Schneider Electric Xantrex™ XW

Software Release Notes

975-0604-01-01
Revision A

Figure 1 Xantrex XW-MPPT60-150 Charge State Diagram

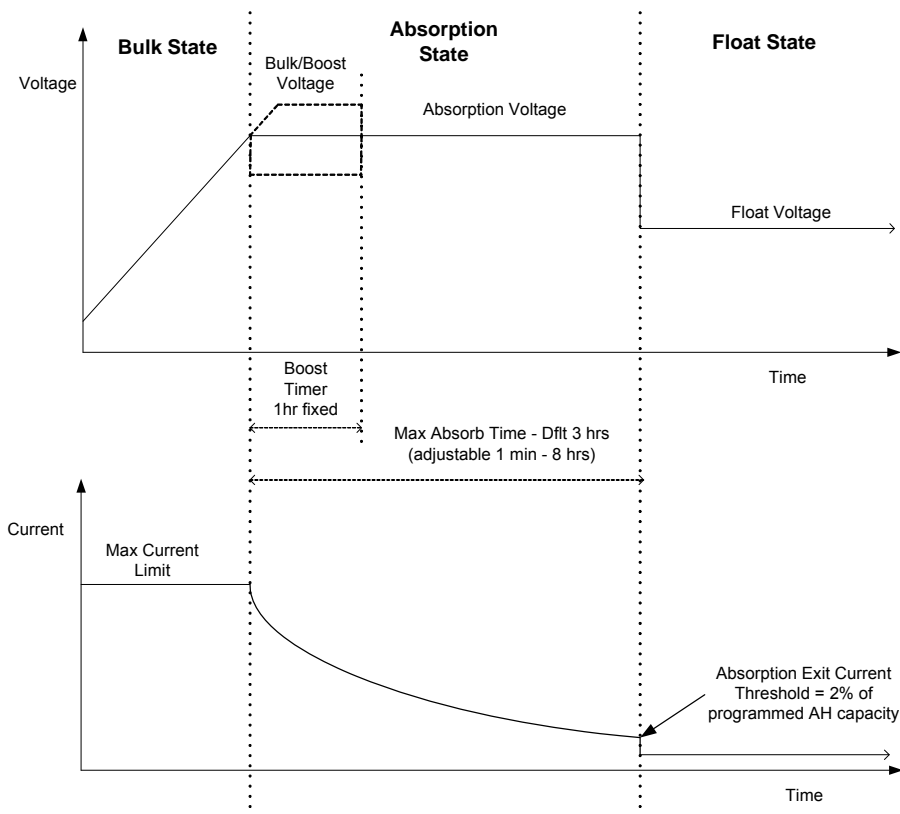
1. The charge algorithm was modified. See the accompanying diagram that shows precisely how the algorithm operates now:
